PROJECT: ST KEVIN'S STRATEGIC HOUSING DEVELOPMENT AT THE FORMER ST. KEVIN'S HOSPITAL AND GROUNDS, SHANAKIEL, CORK

#### DOCUMENT TITLE: CIVIL ENGINEERING INFRASTRUCTURE REPORT FOR PLANNING

DOCUMENT NO: 19.305 - IR - 01

Figure 1: Parking Bay on Bend in Alignment

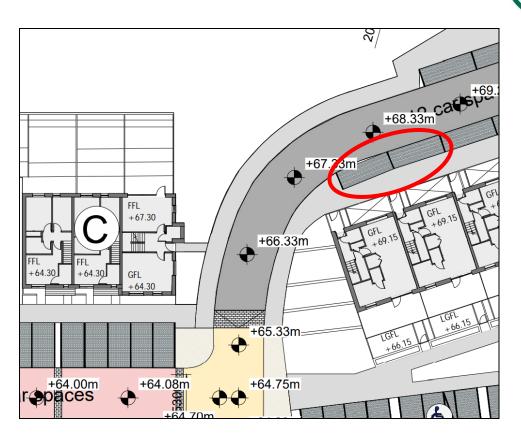
Some parking bays, particularly those on bends in the alignment, may obstruct forward visibility when occupied. This may lead to traffic progressing without appropriate knowledge of other road users or hazards in the carriageway. An example is shown in Figure 1 below.

Some parking bays, particularly those on bends in the alignment, may have reduced visibility to oncoming traffic when attempting to access or egress the parking bay. This may lead to vehicles emerging into the path of oncoming traffic. An example is shown in Figure 1 above.

Ensure that adequate forward visibility can be maintained with all roadside features fully occupied.

Figure 2: Occupied Parking Bays may Obstruct Visibility Splay

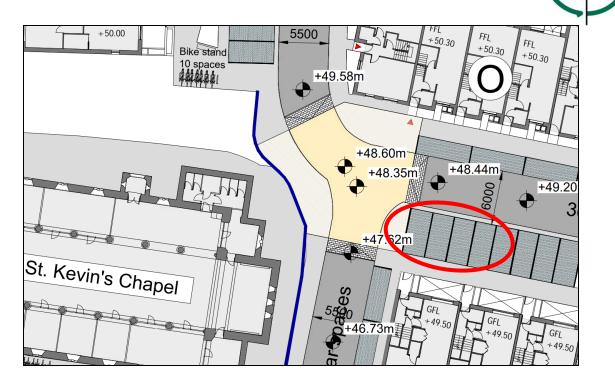
For traffic yielding at the southern arm of the junction in the vicinity of St. Kevin's Chapel, occupied parking bays, some of which are shown in Figure 2, may obstruct the visibility splay to the right. This may lead to vehicles emerging into the path of oncoming traffic.

Ensure that adequate junction visibility can be maintained with all roadside features fully occupied.
